# Central-West Orana Renewable Energy Zone Transmission project

Submissions Report

March 2024

Figure 7-1 Areas recommended by BCS for further avoidance and minimisation of impact in the Kerrabee RNI stage (Moolarben and Wilpinjong mine lands)

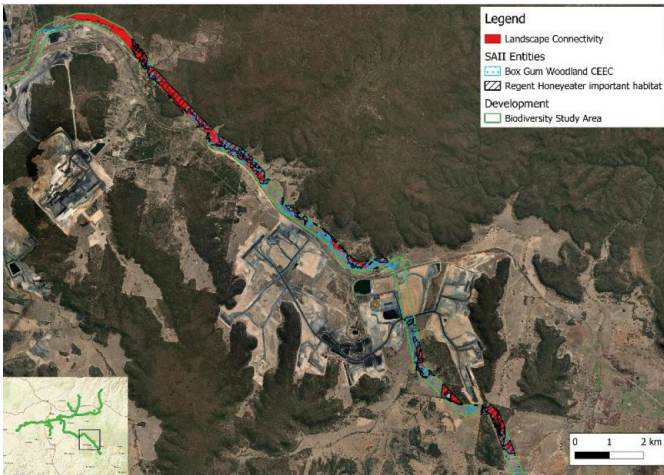
Figure 7-1 shows the potential impacts to habitat connectivity as outlined by BCS for the Kerrabee RNI stage (Moolarben and Wilpinjong mine lands). The areas with less vegetation and habitat to the south are where the Ulan-Wollar Rd, Gulgong-Sandy railway and existing transmission line are located. Moving any further south from these constraints would place the project in active mining areas which is not feasible. Some of the identified areas of landscape connectivity are considered to be edge effect as the connectivity is already impacted by Ulan-Wollar Road active mining, transmission lines. Moving the alignment south to avoid veg not feasible as there is insufficient space between transmission lines and Ulan-Wollar Road. Further south, connectivity is also limited already by Wollar Road and Peabody active mining, and existing transmission line.

Figure 7-2 Areas recommended by BCS for further avoidance and minimisation of impact in the Inland Slopes RNI1 stage and Kerrabee RNI1 stage (private property, Ulan mine and Moolarben land)

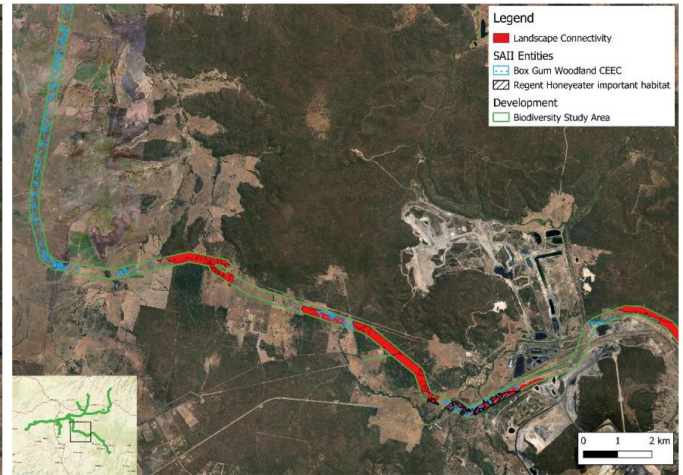
Figure 7-2 shows the potential impacts to habitat connectivity as outlined by BCS for the Inland Slopes RNI1 stage and Kerrabee RNI1 stage (private property, Ulan mine and Moolarben land). In these areas the alignment has sought to minimise impacts to veg by placing it adjacent to an existing transmission line. Moving it further south to completely avoid vegetation and habitats is not possible due to the presence of the existing transmission line. Based on the extent of surrounding vegetation and habitats, complete avoidance of in this section of the project is not possible. Moving the alignment south into the cleared areas not proposed as it would be placed very close to existing dwellings either side of Cope Road. Moving the alignment north is not feasible as it conflicts with Ulan road, Sandy hollow/Gulgong railway, and active mining areas.

Figure 7-3 Areas recommended by BCS for further avoidance and minimisation of impact in the Inland Slopes RNI1 stage and Merotherie Hub (private property)

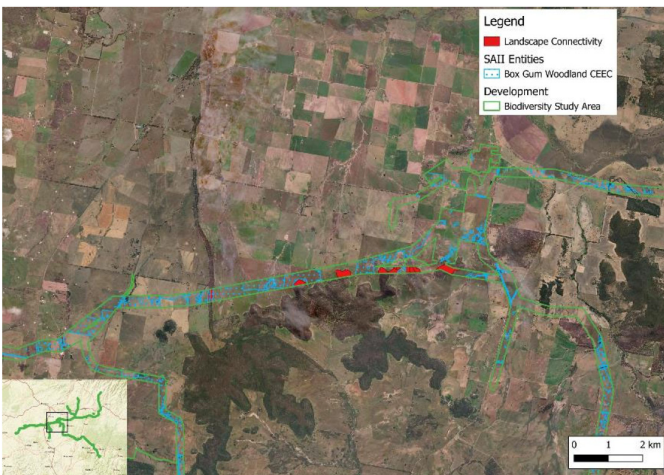
Figure 7-3 shows the potential impacts to habitat connectivity as outlined by BCS for the Inland Slopes RNI1 stage and Merotherie Hub (private property). The alignment impacts the northern most edges of vegetation on a sandstone formation known as Barneys Reef. Some of the identified areas of landscape connectivity are considered to be edge effect as connectivity is already impacted and physical habitat connectivity is non-existent to the north. Moving the alignment north would conflict with the Barneys Reef wind farm so is not possible from a design perspective.

Figure 7-4 Areas recommended by BCS for further avoidance and minimisation of impact in the Inland Slopes RNI1 stage (private property directly north of Tuckland State Forest)

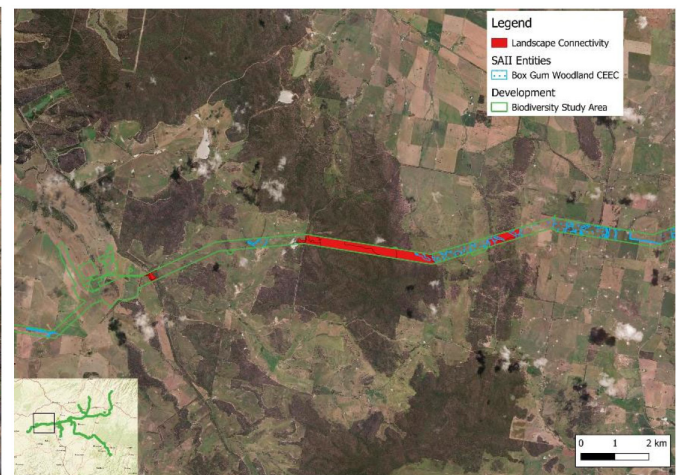
Figure 7-4 shows the potential impacts to habitat connectivity as outlined by BCS for the Inland Slopes RNI1 stage on private property directly bordering Tuckland State Forest. In this area the alignment selected a narrower section of an otherwise potentially larger corridor which would have resulted in greater impacts to vegetation and habitat connectivity. Tuckland State Forest is located north and south of the private property that would be impacted, and as can be seen by this aerial photo complete avoidance of this habitat corridor is not possible. The alignment impacts a narrow section of a riparian corridor associated with Laheys Creek along Spring Ridge Road. Moving the alignment north or south would impact a greater extent of vegetation and habitats, and as demonstrated by this aerial photo, complete avoidance is not possible.

Figure 7-5 Areas recommended by BCS for further avoidance and minimisation of impact in the Kerrabee and Pilliga Valley of the Winds and Liverpool Ranges stages (private property)

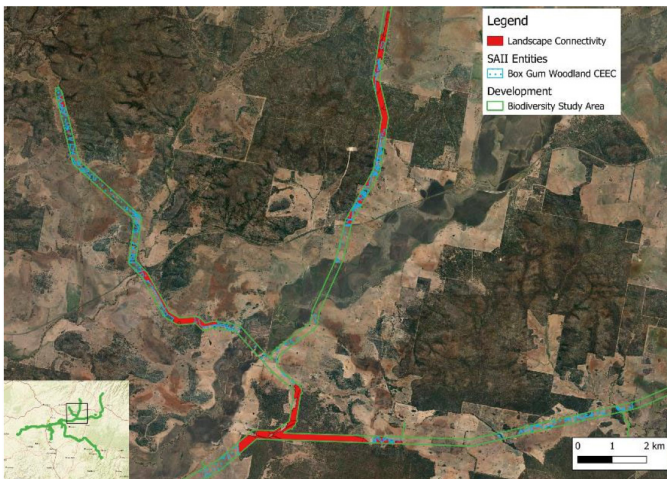
Figure 7-5 shows the potential impacts to habitat connectivity as outlined by BCS for the Kerrabee and Pilliga IBRA subregions Valley of the Winds and Liverpool Ranges stages (private property). In these areas, moving the alignment to avoid impacting the vegetation and habitats at these locations would impact new landowners that are not currently impacted. In this regard, the alignment was selected to maintain the same alignment as the Valley of the Winds development given landowner agreements had already been secured. Moving both 330kV alignments adjacent to the Talbragar River is not proposed due to the presence of BSAL, would require the alignment to move very close to a dwelling, and is more challenging as it would run parallel to Blue Springs Road.

Figure 7-6 Areas recommended by BCS for further avoidance and minimisation of impact in the Pilliga Liverpool Range stage (Durridgere SCA)

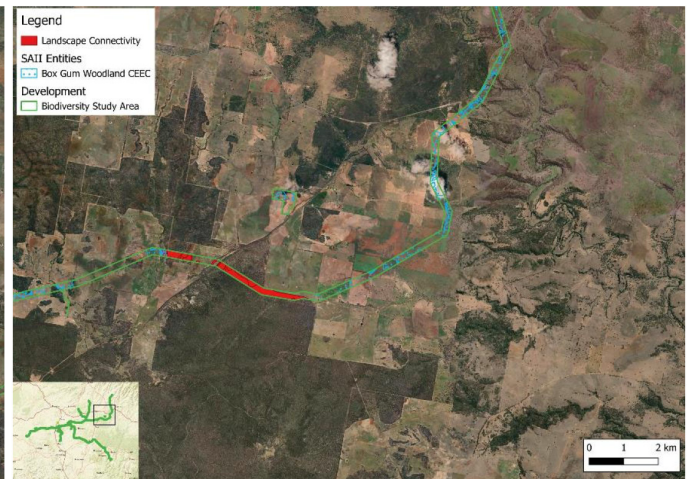
Figure 7-6 shows the potential impacts to habitat connectivity as outlined by BCS for the Durridgere SCA within the Pilliga Liverpool Ranges Stage. In this area, the alignment was previously north and avoided SCA. The alignment was moved based on landowners hosting the Liverpool Range project being impacted greater than what was agreed and creating uncertainty and potential confusion between the two transmission alignments. To provide continuity and certainty, the alignment was changed to align with the Liverpool Range project to a point within the SCA. From here it moves west to reduce impacts to the SCA. It is noted that there will only be one alignment through the SCA, and on the basis Tilt Renewables are successful in their access to the project, it would result in a net reduction in impacts to the Durridgere SCA.
